ITEM FOR ENVIRONMENTAL COMMISSION AGENDA

COMMISSION MEETING DATE:	April 7th, 2021
NAME & NUMBER OF PROJECT:	Omni Business Park, SP-2019-0300C
NAME OF APPLICANT OR ORGANIZATION:	Chris Bradford, Jackson Walker, LLP
LOCATION:	7305 Burleson Road, 78744
COUNCIL DISTRICT:	District 2
ENVIRONMENTAL REVIEW STAFF:	Kristy Nguyen, Environmental Review Specialist Senior, Development Services Department, (512) 974-3035, Kristy.Nguyen@austintexas.gov
WATERSHED:	Onion Creek, Suburban, Desired Development Zone
REQUEST:	Variance request is as follows: Request to vary from 1993 Comprehensive Watershed Ordinance, Section 13-7-16(a) – for a fill exceeding four feet
STAFF RECOMMENDATION:	Staff recommends this variance, having determined the findings of fact to have been met.
STAFF CONDITION:	1) Preserve top 12 inches of topsoil to be used onsite; 2) Increased landscaping for areas of fill to stabilize erosion; and 3) Provide enhanced erosion & sedimentation controls during construction.

Development Services Department
Staff Recommendations Concerning Required Findings

Project Name:	Omni Business Park
Ordinance Standard:	1993 Comprehensive Watershed Ordinance
Variance Request:	Section 13-7-16(a) – for

Cut Fill Exhibit

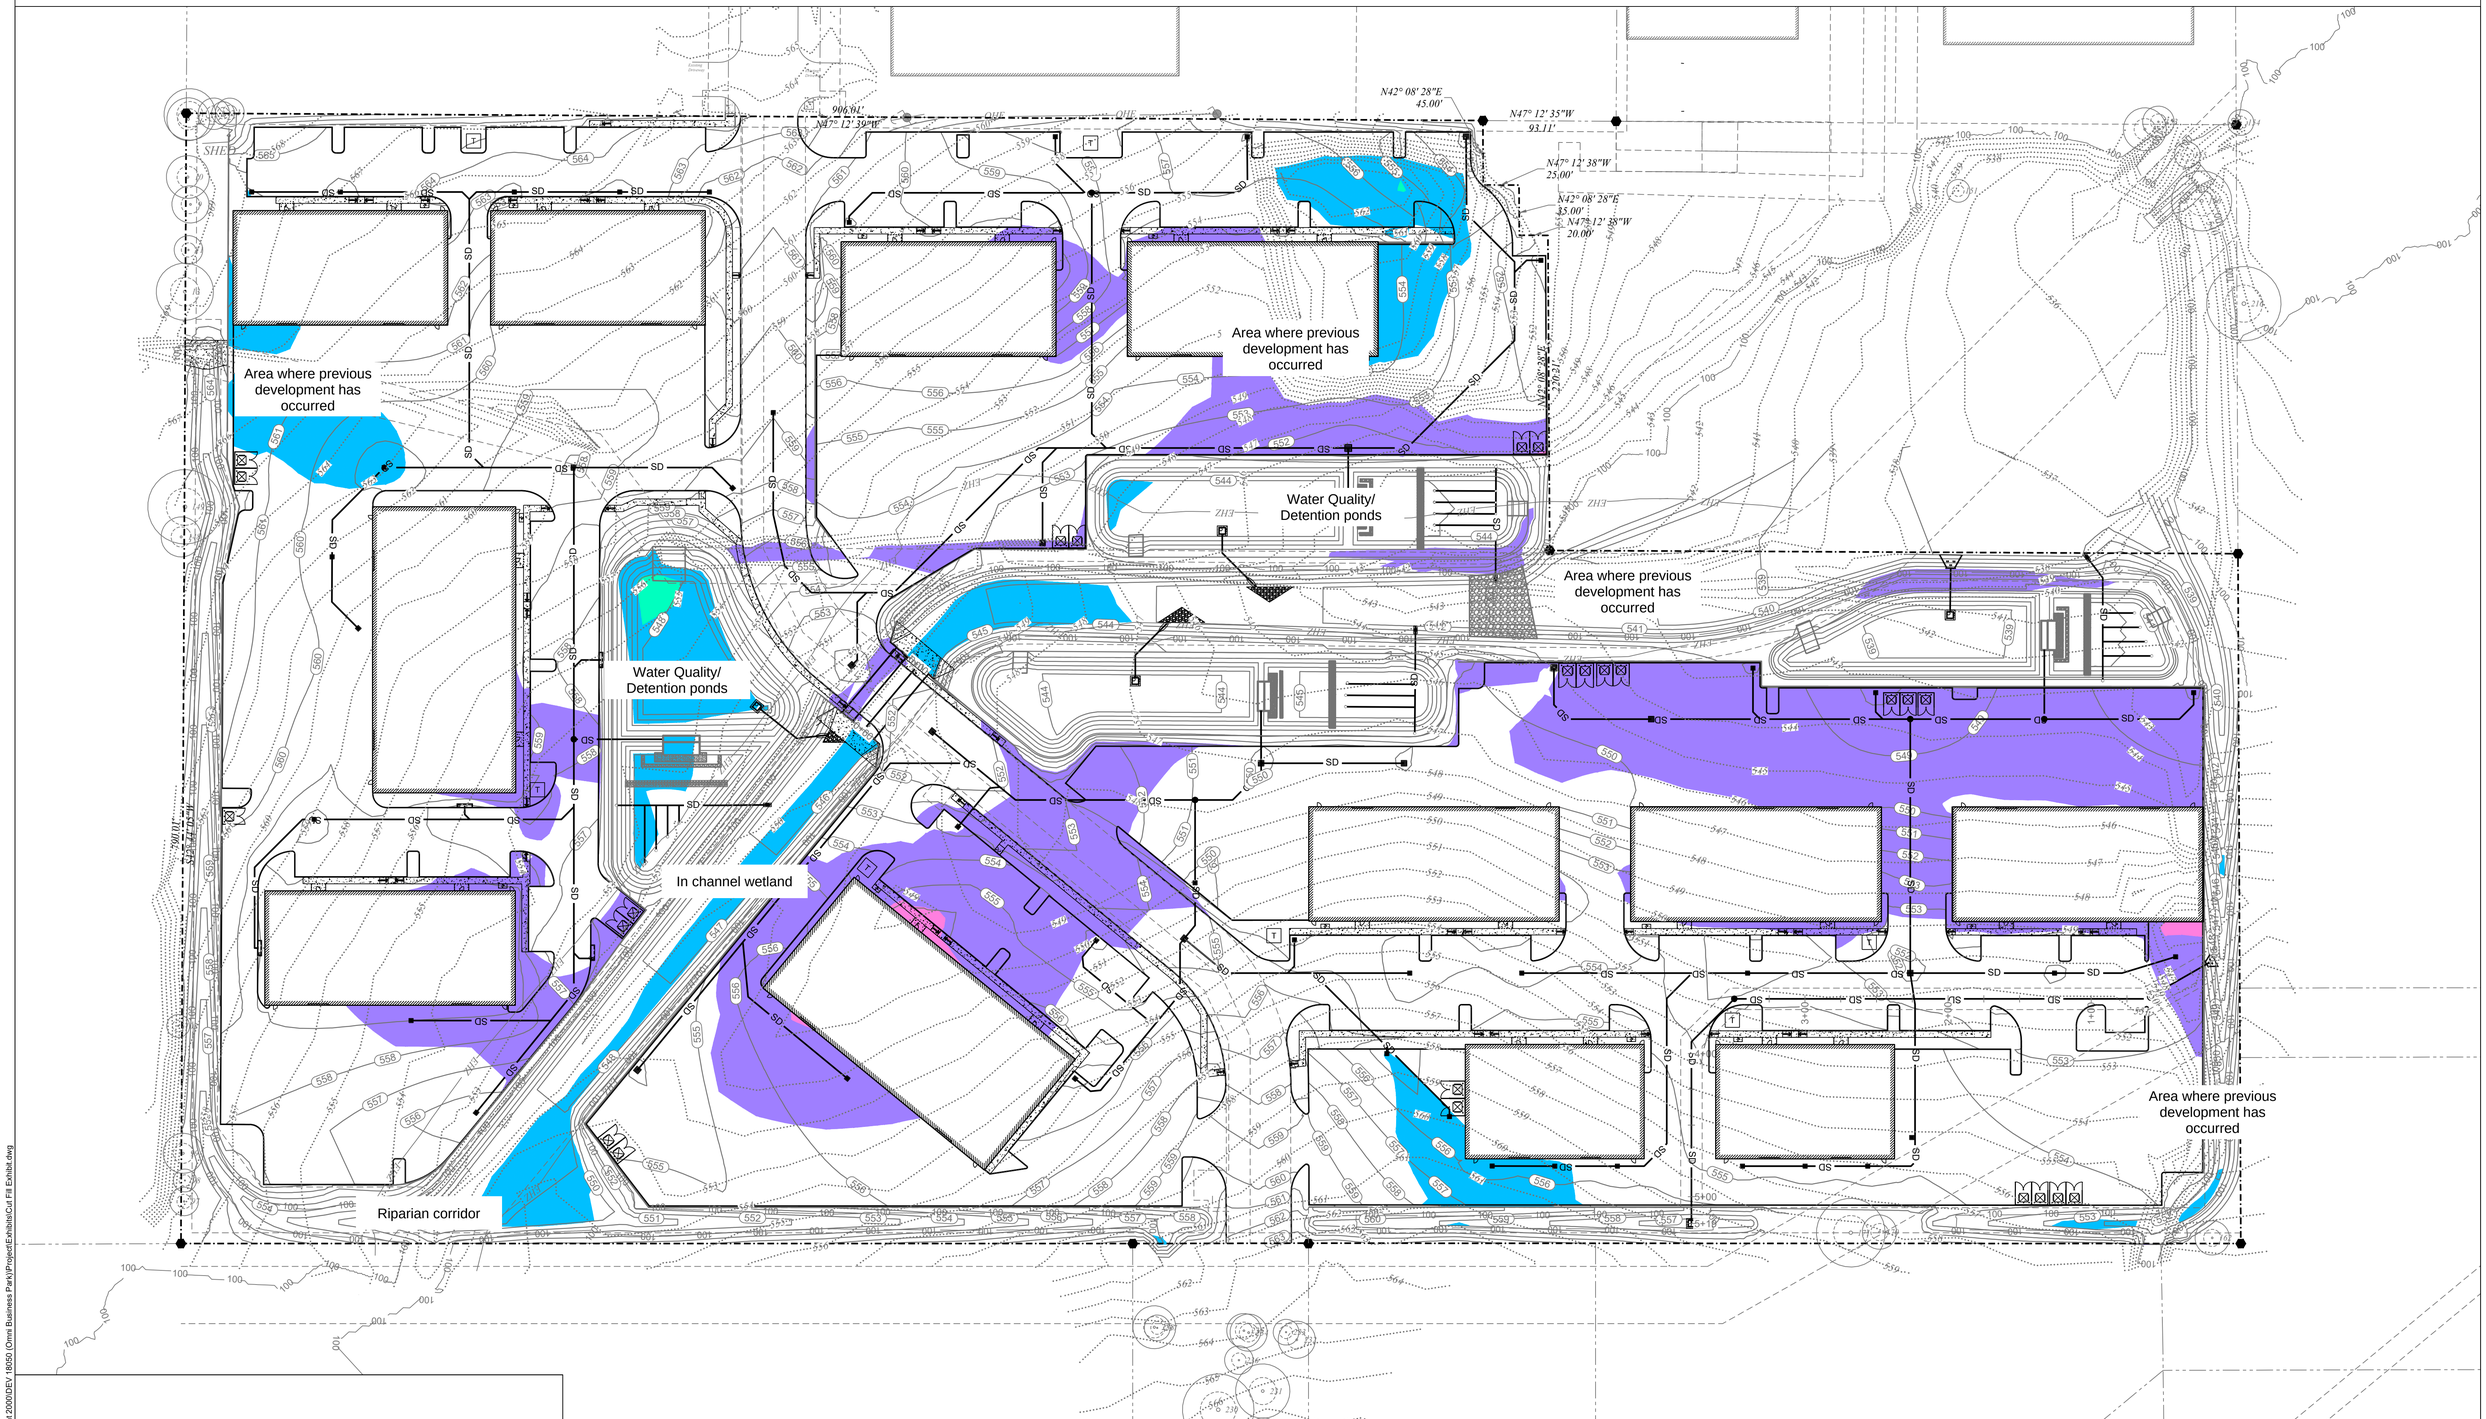
Yes The fill limits of the site will not exceed eight feet and will be structurally contained with retaining walls. To further stabilize areas of fill exceeding four feet, a planting plan with robust plantings will be incorporated where feasible. In addition, areas of fill exceeding four feet are to address the previous construction activities occurred onsite. For these reasons, the variance request to exceed the four feet fill limit will not create significant probabilities of harmful environmental consequences.

Clearly indicate in what way the proposed project does not comply with current Code (include maps and exhibits)	The plan complies with all applicable codes in place as of the original final plat application date of June 9, 1993, except the 4' cut and fill limitation depicted on the cut map provided.

1) Preserve top 12 inches of topsoil to be used onsite;
2) Increased landscaping for areas of fill to stabilize erosion; and
3) Provide enhanced erosion & sedimentation controls during construction.
